Rezoning Transportation Analysis

Petition Number: 2017-190 General Location Identifier: 08906439

Date	Description	
12-12-17	First Review	
01-22-18	Second Review

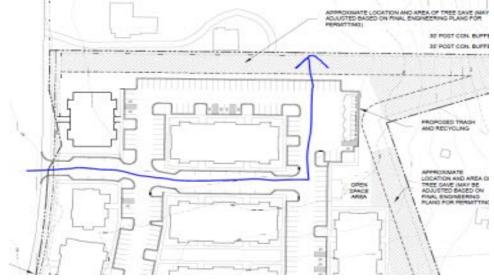
5. The petitioner should revise the site plan and conditional note(s) to revise the drive aisle shown below to allow permanent public access, use a form consistent with a public street section, and create a stub for future connection and cross access from adjacent parcels.
